| CHECKED # | APPROVED # | DRAWING NO. DSI 9204 | REV. A SHEET 1 OF 1 |
| DATE 01.04.26 | | TITLE DART 350/355 SKID/STEP INTERFACE NTS | |

DART SERVICE INSTRUCTION

TO AMEND INSTALLATION DRAWING D350-591 REV. D

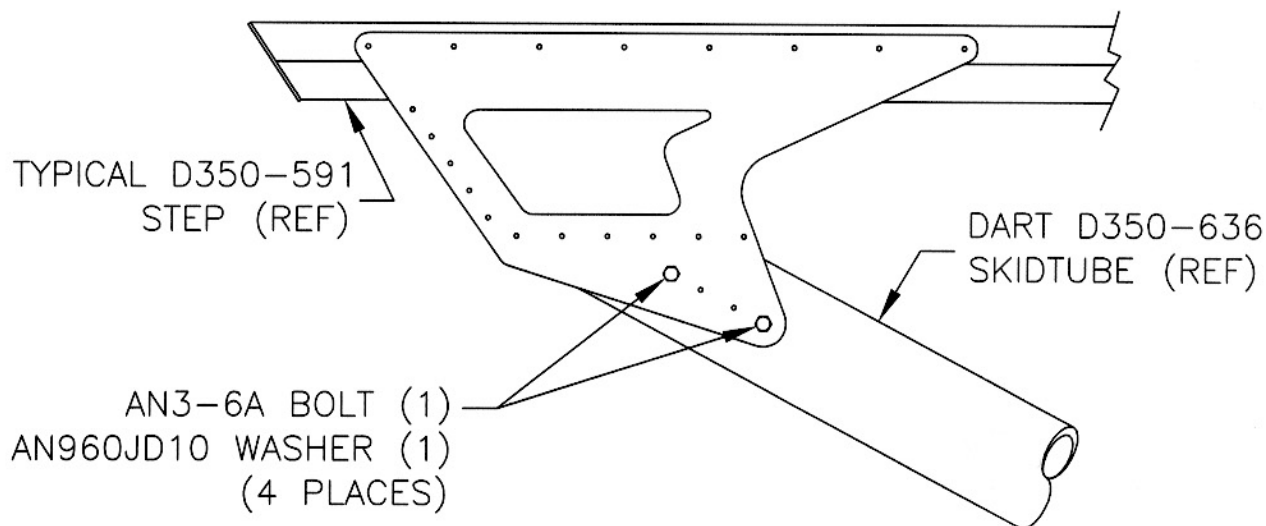
WHEN INSTALLING THE DART D350-591 STEPS ON DART D350-636 SKIDTUBES (REF. CANADIAN STC SH99-7, FAA STC SR00646SE), THE AN3-37A BOLTS (2), MS21042L3 NUTS (2), AND AN960JD10 WASHERS (2) CALLED UP IN THE PARTS LIST OF D350-591 REV. D ARE NOT REQUIRED. USE THE AN3-6A BOLTS (4) AND AN960JD10 WASHERS (4) THAT ARE PROVIDED WITH THE SKIDTUBES INSTEAD, AS SHOWN BELOW.
